**Economic and Social Council**Distr.: General
10 July 2015

Economic Commission for Europe**Inland Transport Committee****World Forum for Harmonization of Vehicle Regulations****Working Party on General Safety Provisions****109th session**

Regulation No. 43 (Safety glazing)**Proposal for amendments to Regulation No. 43 (Safety glazing)****Submitted by the expert from Hungary***

Figure 4

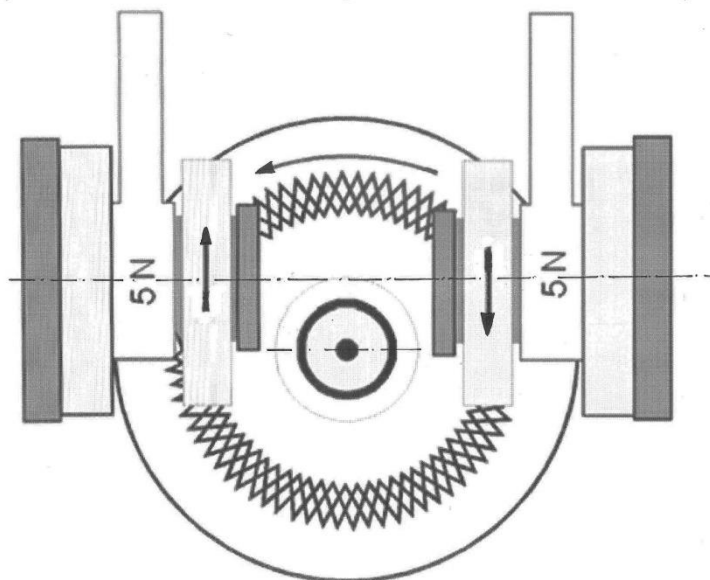
Annex 3, paragraph 4.1.1., amend to read (keeping footnote ² but replacing Figure 4):

1. The offset of the axis and the distance of the wheels are currently not specified and Figure 4 shows no offset between the axes. However, the offset and the distance have a considerable influence on the sliding impact between the wheels and the glass, i.e. to the abrading effect. Therefore, both shall be specified as proposed above.

Two weighted parallel arms each carrying a special abrasive wheel freely rotating on a ball-bearing horizontal spindle; each wheel rests on the test specimen under the pressure exerted by a mass of 500 g.

The distance between the symmetry planes of the wheels shall be 65 mm and the offset of the wheel axis from the turntable axis shall be 19 mm.

Wheels shall be placed evenly on the specimen in their full width so that the abrasion is nearly the same within the full width of the abraded area. Abraded particles shall be sucked away during the test so that they do not influence abrasion.
